3571 Cassie Drive SW

기존 3-car garage → AFH 거주구역 전환 (침실 3 + 통합욕실)

AFH 전환 (기존 3-car garage) - 허가 제출용 스키매틱

Project No. CMN/25/122 Date OCT 2026

GROUND FLOOR (Existing)

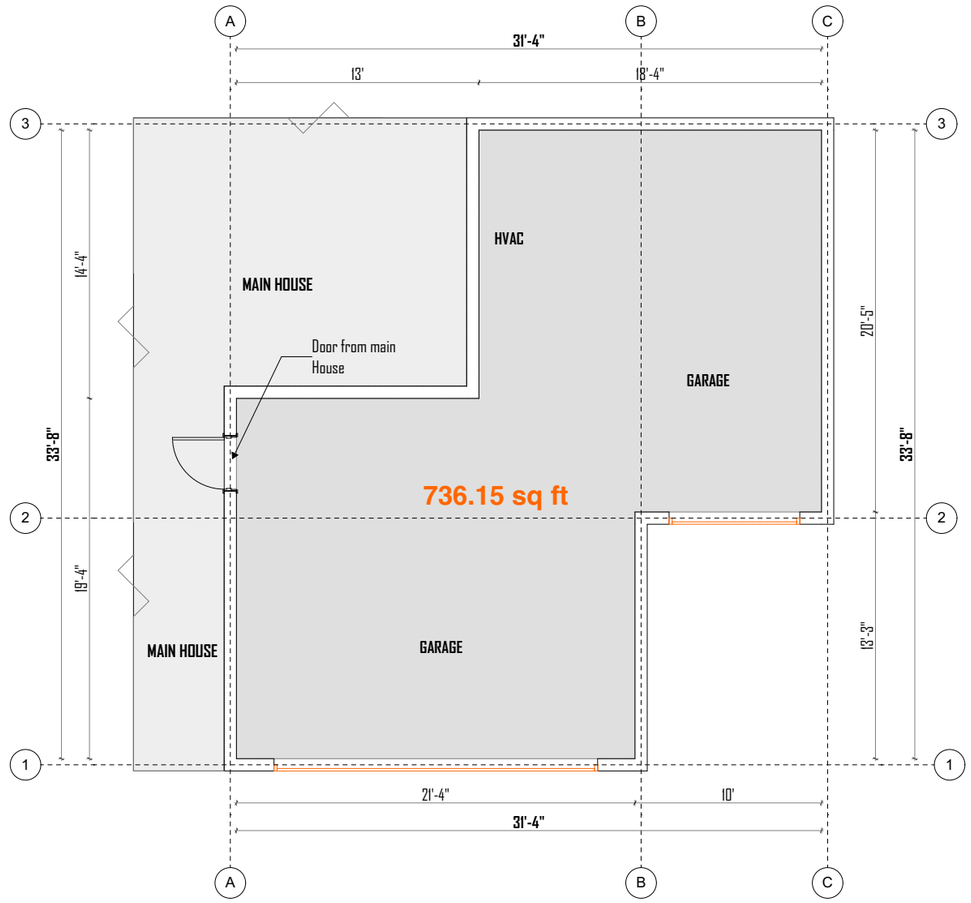
R-3 · Two different floor-area figures for the same conversion.
The specification set describes a **738 SF** conversion; the county record shows a **790 SF** attached garage and the architect's A01.3/A01.4 state **790 SF existing / 736 SF internal**. Sheet A-12 uses the A01.4 basis.
Action: declare one area on the application (recommend A01.4: 790 SF existing, 736 SF internal).

R-4 · Lot identity and area.
County legal description: **Lot 7**, 9,411 SF. Recorded survey cover sheet: **Lot 1**, 9,357 SF. MLS: 9,408 SF. Sheet G-06 carries the conflict; C-01 uses the survey area for coverage (37.6 %).
Action: confirm the lot number on the plat before uploading the survey as an appendix.

A01.3

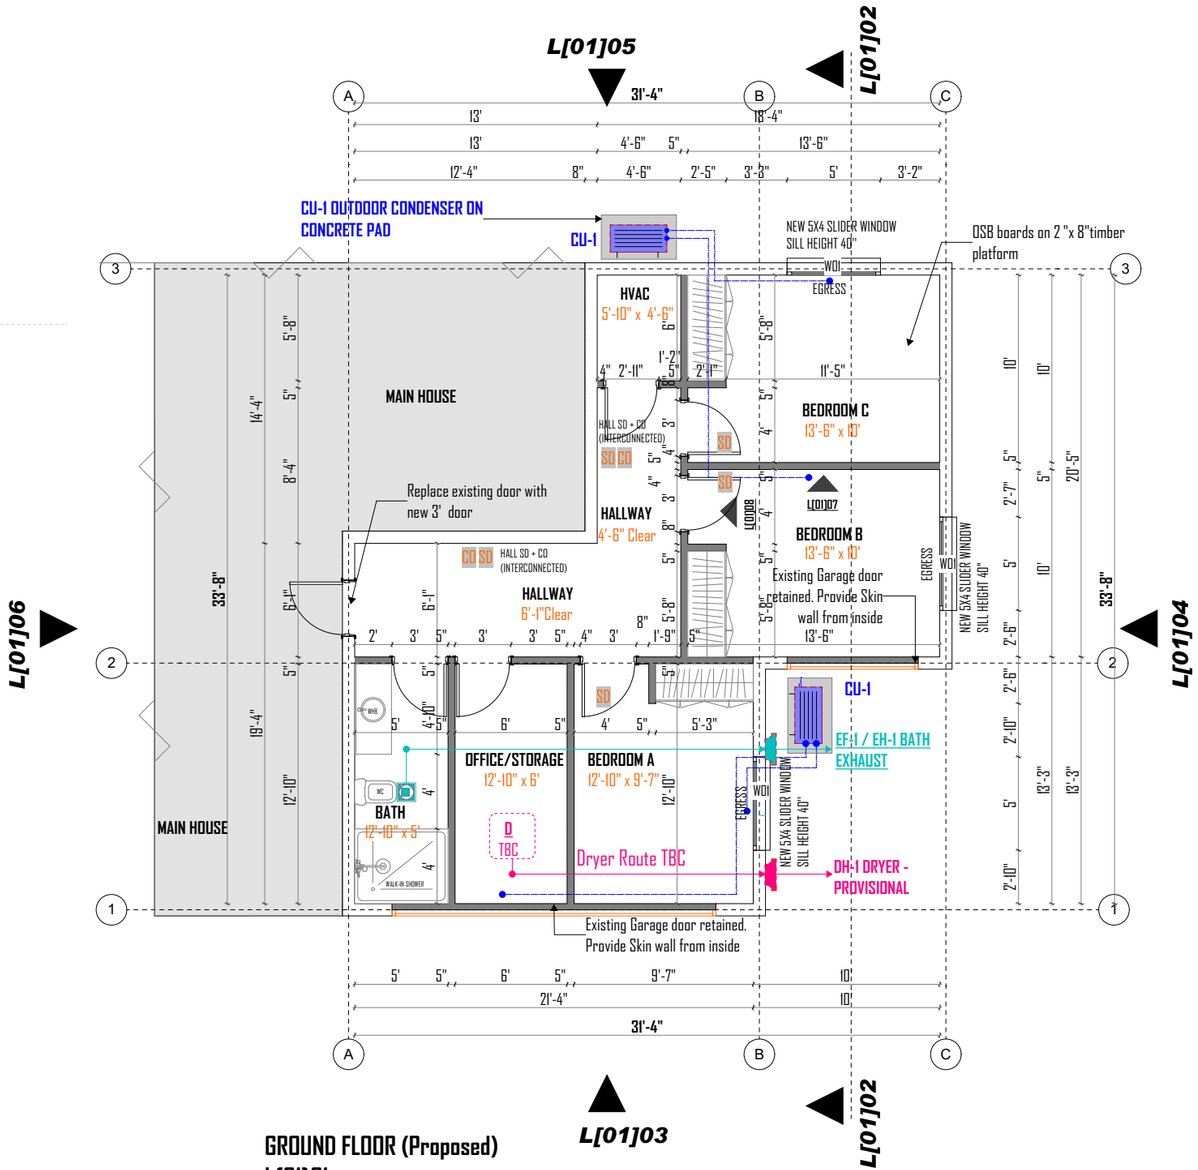
ID / status	Exact point on the source page / current wording	Finding and requested correction / decision
3A Checked	Plan perimeter, grid 1–3 / A–C: 13′3″+20′5″; 19′4″+14′4″; 21′4″+10′; 13′+18′4″.	These close to 33′8″ and 31′4″. Architect: field-verify the controls and adopt one canonical dimension set. Proposed plan, elevations and section must then use those same controls (4A, 5A, 6C).
3B Clarify	Orange center label “736.15 sq ft”; below-plan caption “Total internal floor area=736 sq ft”; right summary “Existing Garage Area:790 SF.”	736.15→736 is acceptable rounding. Define 790 gross-area boundary versus 736.15 internal footprint; difference is not itself an error. Relabel proposed usable room areas separately, after walls/closets/HVAC exclusions.
3C Add elevations	Left-middle callout “Door from main House”, grid A near 2; MAIN HOUSE labels at left; GARAGE area shaded gray.	Survey garage slab, main-house finished floor, connecting door threshold and exterior grade. Show these datums and demolition/retention extent. The future raised floor cannot be coordinated without the existing level relationship.

3D Add information	Upper central/right plan zone labeled HVAC; exterior garage openings at bottom and right edge near grid 2.	Document actual HVAC/appliance type, fuel, venting/service needs and opening framing. Identify existing utilities and any alterations. Do not presume a mechanical closet is adequate merely from the label.
3E Editorial	Below-plan view L{01}01: “SCALE:1/4″=1′-0″”; right title-block scale 1:50 and “Ground Floor Plan -Before.”	1/4″=1′ is 1:48, not 1:50. Verify plotted output and use one scale or “As shown.” Use “Existing Ground Floor Plan.” See page 10 for common title/footer changes.

Reply by ID: Item_____ □Agree □Clarify □Alternative Revised sheet/rev_____ Date_____
Architect response / homeowner decision:_____

A01.4

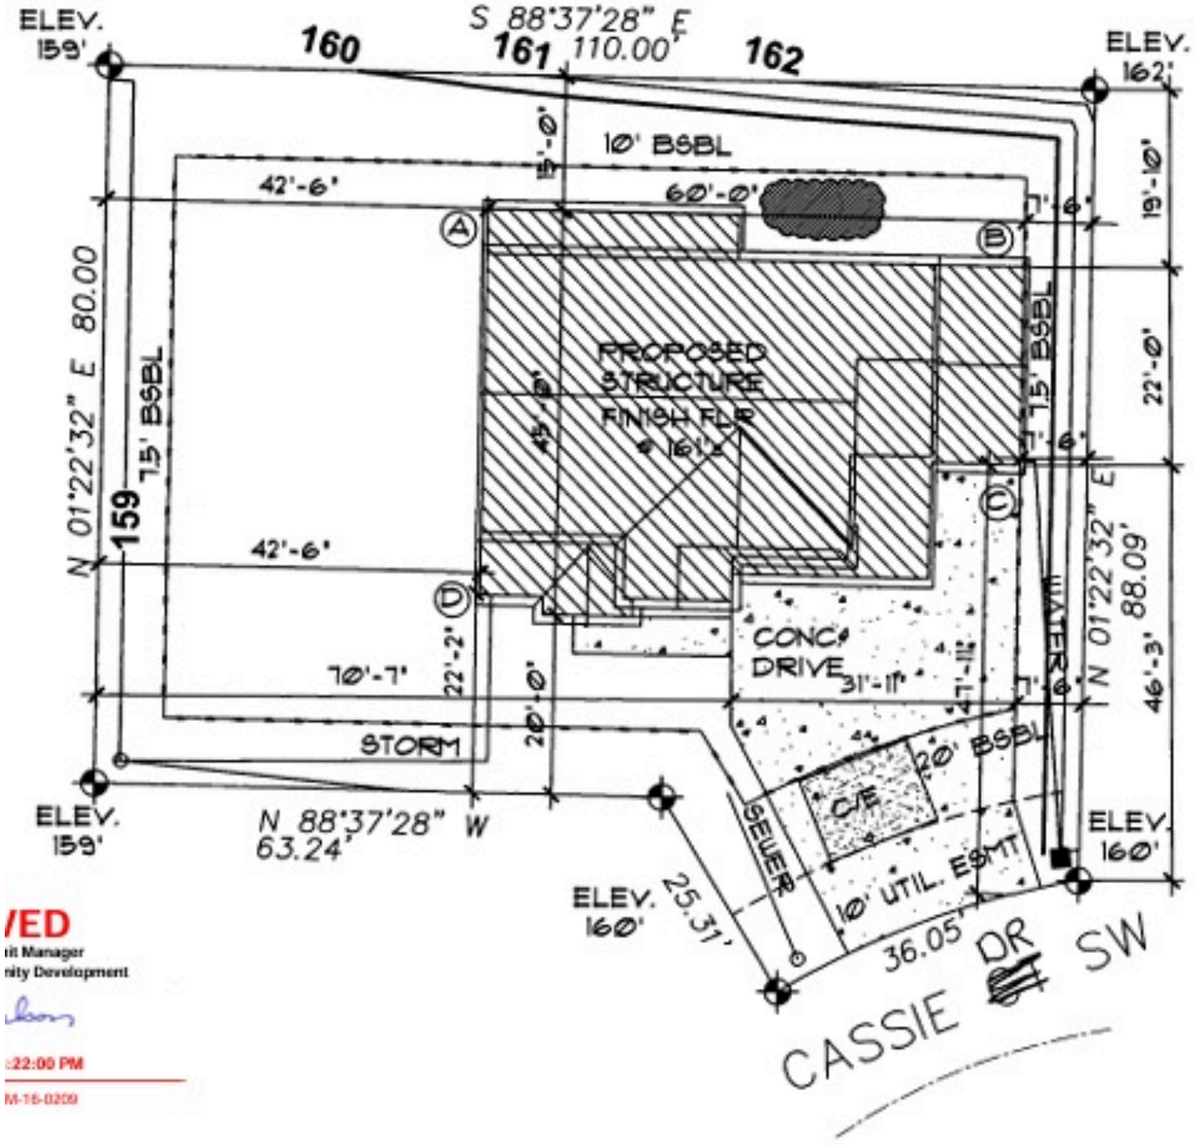
4A1–4A7 are written-dimension conflicts. Verify grid/face endpoints and canonical controls; regenerate all chains. Do not arbitrarily reduce a selected segment.

ID	Source point	Printed chain	Computed / control
4A1	Above plan, second A–C dimension row	13′+4′6″+5″+13′6″	31′5″ vs 31′4″
4A2	Below plan, innermost A–B row	5′+5″+6′+5″+9′7″	21′5″ vs 21′4″
4A3	Left detailed vertical row beside main-house outline,1–3	12′10″+5″+6′1″+8′4″+5″+5′8″	33′9″ vs 33′8″
4A4	Inside plan, vertical hall/Bedroom B–C partition,2–3	5′8″+5″+4′+5″+4′+5″+5′8″	20′7″ vs 20′5″
4A5	Inside plan, horizontal chain immediately above Bedroom A	4′+5″+5′3″	9′8″ vs 9′7″
4A6	Right detailed exterior/window row beside Bedroom B above grid 2	2′6″+5′+2′7″	10′1″ vs 10′
4A7	Right detailed exterior/window row, lower 1–2 portion	2′10″+5′+2′10″+2′6″	13′2″ vs 13′3″

ID / status	Exact point on the source page / current wording	Finding and requested correction / decision
4B Verify	Bedrooms A/B/C and wardrobes; HVAC in upper-center labeled 5′10″×4′6″; BATH bottom-left 12′10″×5′.	Add occupancy/net-usable-area and dimensioned bathroom schedules. A ≈ 122.99 SF before exclusions; B/C135 SF before exclusions; C minus HVAC 26.25 SF gives ≤ 108.75 SF before wardrobe. No demonstrated double occupancy for C; A has only 2.99 SF margin. Exclude closets/wardrobes/vestibules; 80 SF single/120 double. Show shower final clearance, bars/backing, fixtures/door circulation.
4C Add schedule	Middle-left leader “Replace existing door with new 3′ door”; MAIN HOUSE connections; window labels “SILL HEIGHT 40″”/EGRESS.	Nominal 3′ is not installed clear width. Schedule doors/thresholds and complete exit route/classifications (page 10). Show actual clear egress-window data (7B). Coordinate raised floor/retained-door wall with 6A/6B/6D. Homeowner: confirm intended single/double occupancy.

4D Finalize	Right MECHANICAL ROUTES / PRELIMINARY / VERIFY; two blue CU-1 symbols; conditional D/DH-1 dryer in Office/Storage.	Confirm one/two units and unique tags; specify indoor units, capacity, airflow, duct/pipe sizes, condensate/service/penetrations and actual termination façade. Homeowner: decide dryer inclusion/location. Remove placeholder/TBC/[1] or supply final design/source.
4E Rewrite	Right, directly below LEGEND: “...BATTERY BACK UP PER WAC R314.4 AND IRC 314.4, R315.5.”	Use listed smoke/CO “alarms”; correct complete WAC/IRC references, power/backup and whole-home interconnection/audibility. R314.4 alone is not the backup-power rule. Applicable alteration exceptions and visual alarms depend on current rules/resident needs (page 10).

Reply by ID: Item_____ □Agree □Clarify □Alternative Revised sheet/rev_____ Date_____
Architect response / homeowner decision:_____
